Planning Permit Application PA2504156 – Response to Request for Further Information

Tract Consultants acts on behalf of 107 High Street Pty Ltd (*the 'Applicant'*), a subsidiary of Up Property, in relation to 107-123 High Street, Belmont (*the 'Site'*).

Figure 1 – Glenara Ct Height Transition

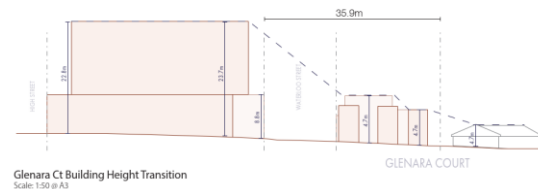
4. *Built form transition — stepping and setbacks to GRZ4 interface*

Previous advice sought additional stepping and upper-level setbacks to achieve a graduated transition to the residential interface. While written justification has been provided asserting that an appropriate transition is achieved through overall height modulation, separation via Waterloo Street, and intervening townhouse development, no corresponding design amendments or detailed built form analysis have been submitted to substantiate this position. In the absence of further information or design refinement, this matter may necessitate resolution through planning permit conditions.

Additional diagrammatic presentation of the transition in building height had been included at page TP02.03 of the enclosed plans. The design prepared by CHC provides a clear and well-considered transition to the GRZ4 interface.

At its foundation, the proposal achieves an appropriate graduation in scale through deliberate height modulation, the physical separation offered by Waterloo Street, and the location of the intervening townhouse component. This transition is demonstrated in the cross-sectional diagrams prepared by CHC, which show a separation of 35.9 metres from the tower element to the nearest existing dwelling on Glenara Court.
